產品變更通知單(PCN)

序號: DOC-PCN-H00010-000

機種名稱 Model No.	ICA-607	日期 Date	2014/03/21
----------------	---------	---------	------------

Base & Cover material comparison pictures:

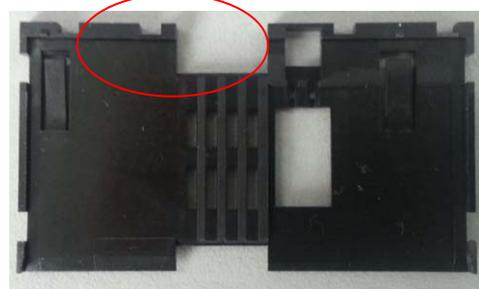
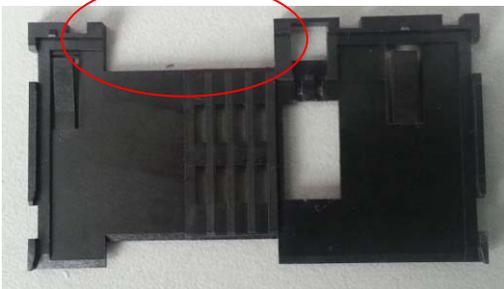
Because product ICA-607 is an ultra-slim type, in order to upgrade its quality, we do optimization as below:

1. Reduce the gap on CP8 area, and add one set of assembly clips on BASE and COVER.
2. Move the Logo to right side.

From above optimization, it can enhance product structure, and the connection between card and CP8 can also get much stable after card inserted. It only has change on product appearance, and won't get impact for function and characteristics and meet original SPEC. Please refer to below comparison pictures.

Reduce the gap,
add one set of
assembly clips
